OHIO DEPARTMENT OF TRANSPORTATION
CENTRAL OFFICE, 1980 W. BROAD ST., COLUMBUS, OHIO 43216-0899

From: Tim Keller, Administrator, Office of Structural Engineering

Re: 2011 Fourth Quarter Revisions

Summary of Revisions to the July 2007 ODOT BDM

SEALING OF CONCRETE SURFACES, SUPERSTRUCTURE

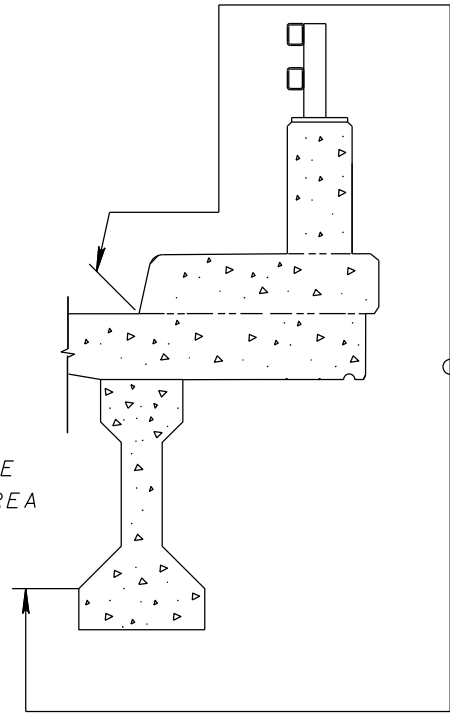
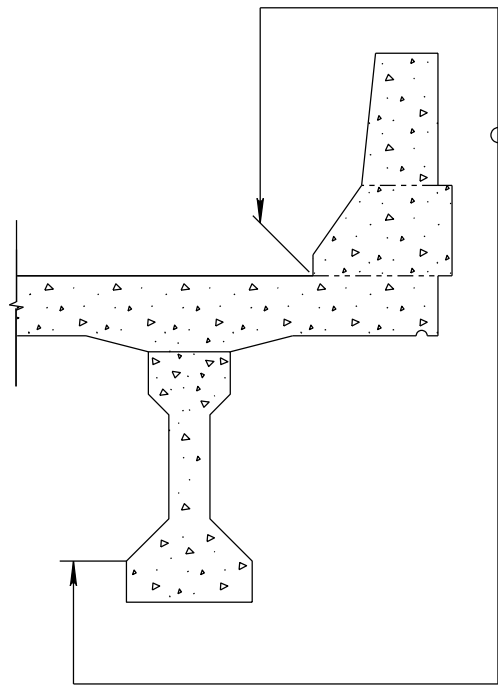
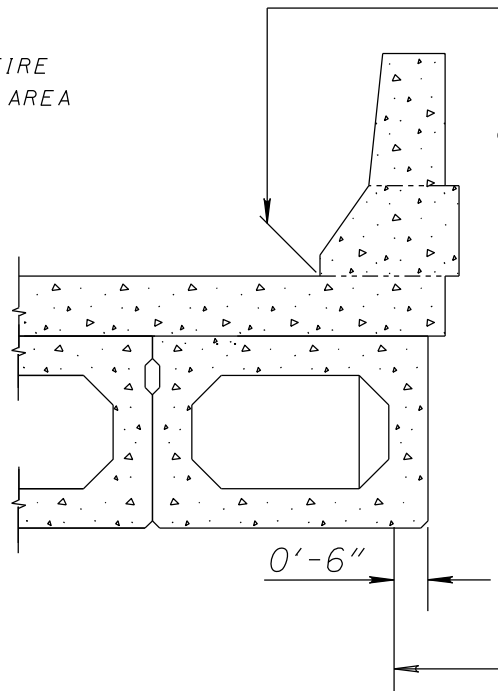
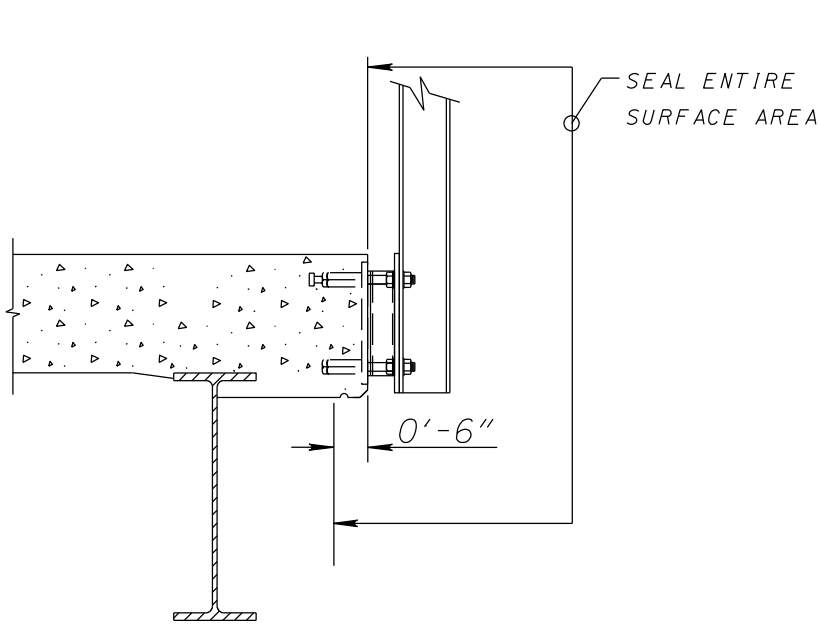
BDM Section	Affected Pages	Revision Description
302.1.4.3	3-11 through 3-12	The 9-inch width of sealing on the bridge deck surface has been eliminated. The epoxy-urethane sealer at this location has a history of poor performance. Since this area is already sealed with HMWM in accordance with C&MS 511.22, the application of epoxy-urethane sealer is not necessary.
Figure 302.1.4.3-1		Refer to BDM Section 302.1.4.3 description above.
Figure 302.1.4.3-2		Refer to BDM Section 302.1.4.3 description above.

Specifications for sealing material are defined in CMS 512. Concrete surfaces shall be sealed with an approved concrete sealer as follows: (See Figures 302.1.4.3-1 & 302.1.4.3-2)

The deck fascia and a 6 inch [150 mm] (minimum) width under the deck shall be sealed with either an epoxy-urethane or non-epoxy sealer.

The vertical face of curb; the top of the curb/sidewalk; the inside face, top and outside face of the parapet; the deck fascia; and a 6 inch [150 mm] (minimum) width under the deck shall be sealed with either an epoxy -urethane or non-epoxy sealer.

The inside face, top and outside face of parapet; the deck fascia; and a 6 inch [150 mm] (minimum) width under the deck shall be sealed with either an epoxy-urethane, or non-epoxy sealer.
